Technical Service Bulletin

Trim for Tailgate Noisy

70 06 03 Oct. 20, 2006, 2012960/1

Model(s)	Year	VIN Range	Vehicle-Specific Equipment
A6	2005 – 2006	All	Not Applicable

Illustration 1

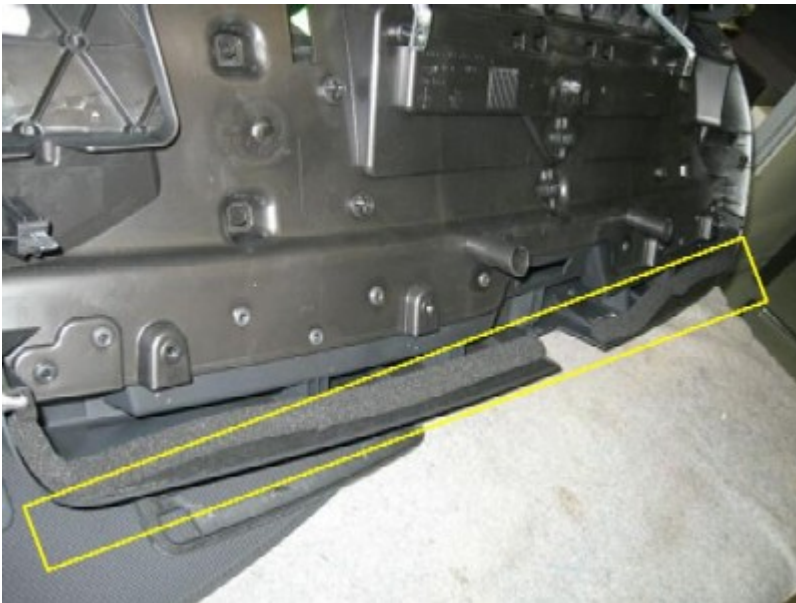
- 1.Remove the tailgate trim and check to see if the foam strip has come off. (See Illustrations 1 and 2.) Remove the old foam, including the adhesive tape, and use new adhesive tape (Part No. 8E0 831 575 A) to reattach the foam.
- 2.Attach felt to all contact surfaces, such as support turrets and edge areas of the trim. (See Illustrations 3 and 4.)
- 3.The plastic turrets must be glued with body bonder to ensure a firm fit, as shown by the yellow circles in Illustration 4.
